PERMIT

P 515282

SEWAGE DISPOSAL SYSTEM
HOWARD COUNTY HEALTH DEPARTMENT
BUREAU OF ENVIRONMENTAL HEALTH
410-313-2640

SUBDIVISION Paternal Gift Farm LOT NUMBER 7 ADDRESS 13537 Paternal Gift Drive

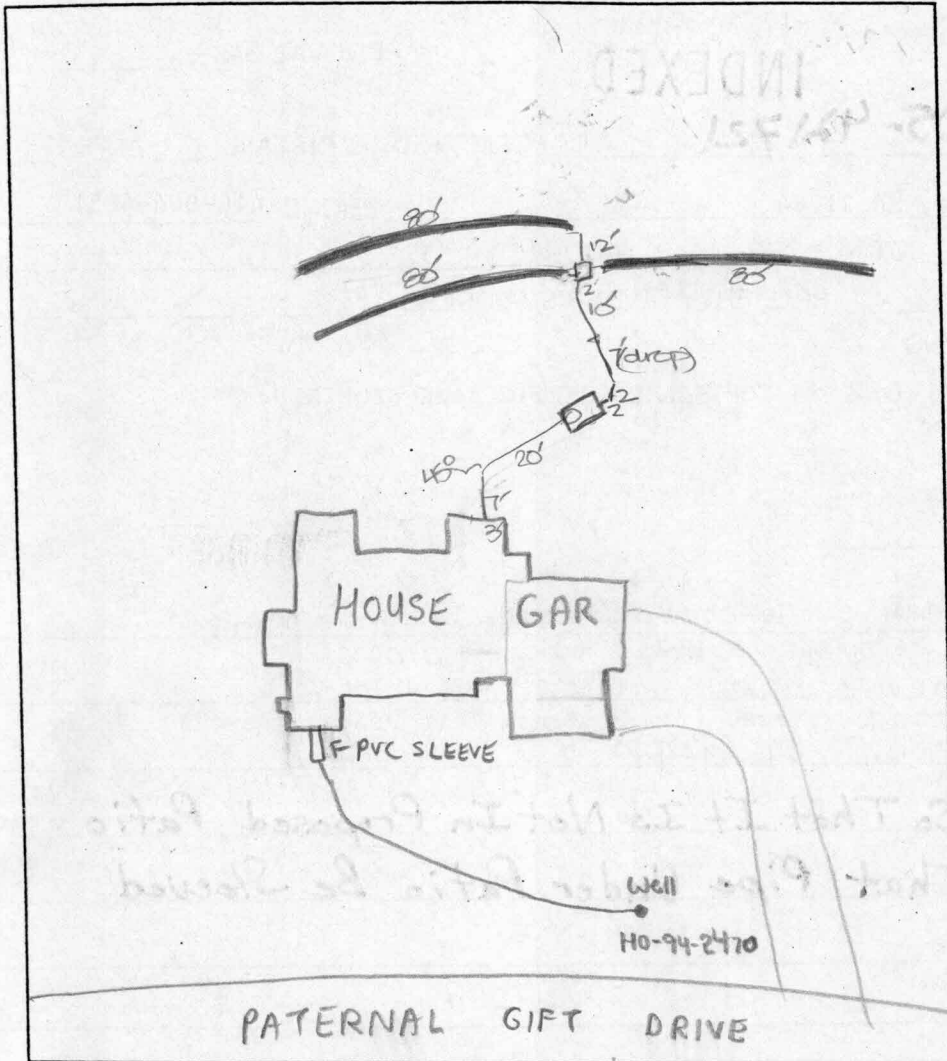
*Set Septic Tank So That It Is Not In Proposed Patio
Area - Suggest That Pipe Under Patio Be Sleeved*

PRE-CONSTRUCTION INSPECTION: 4/13/01 layout confirmed - SDA staked - septic tank set - OK to run trenches in both directions to best utilize SDA. DIC

INSPECTION COMMENTS: 4/13/01 P.M. FINAL INSP - OK to cover all septic work. DIC
